Port of San Francisco

Dry Dock #2

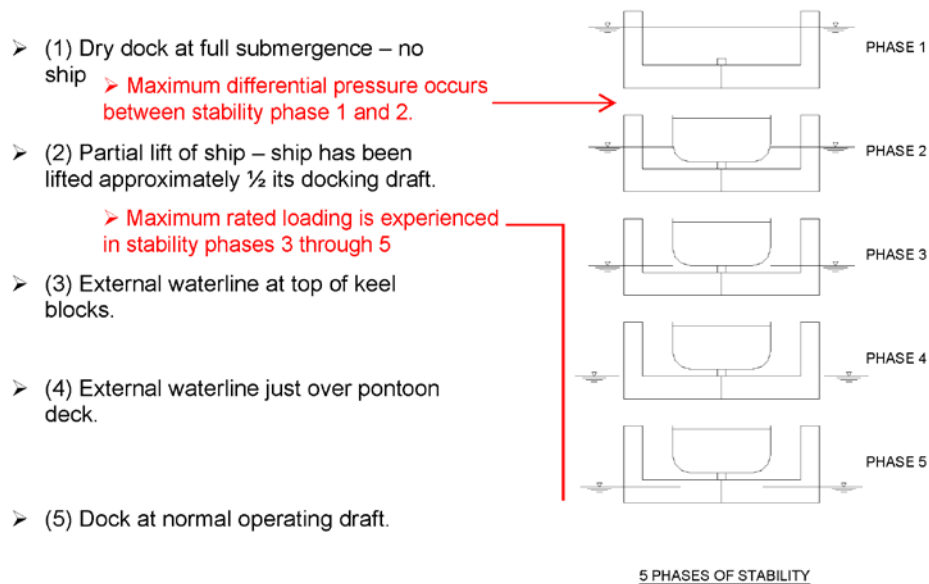
Figure 13: Max Load Cases (Figure from Heger Dockmaster's Training Manual Fig. 5.14, red annotations added for clarification)
